Sydney Opera House VAPS Design Report

In support of s75w Planning Application Sept.2012
Major Project MP09_0200

20100112-Report-PDR2

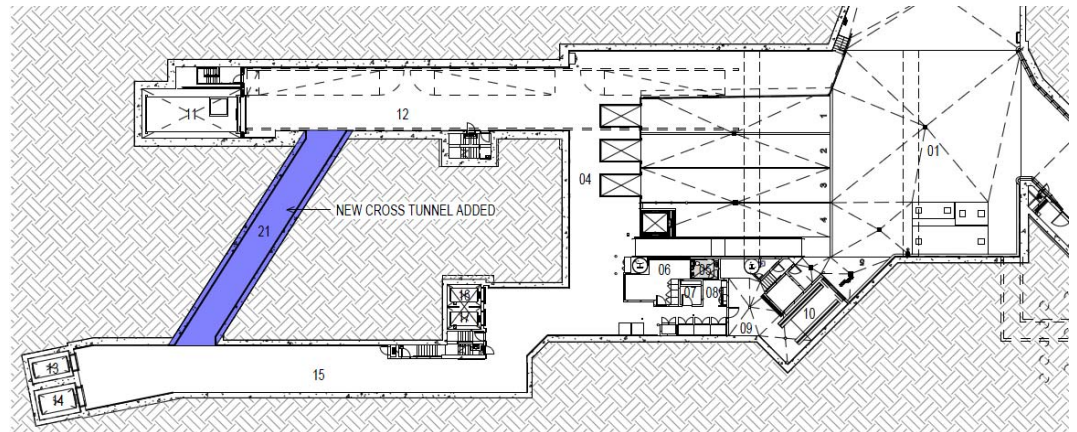
1. Introduction of a Cross Tunnel at B4 level, between the Opera Theatre Corridor and the Concert Hall Corridor at B4 level within the dock.
2. Amendments to the Ramp Balustrade wall and precast panelling at Forecourt level.
3. Amendments to the Gate House.
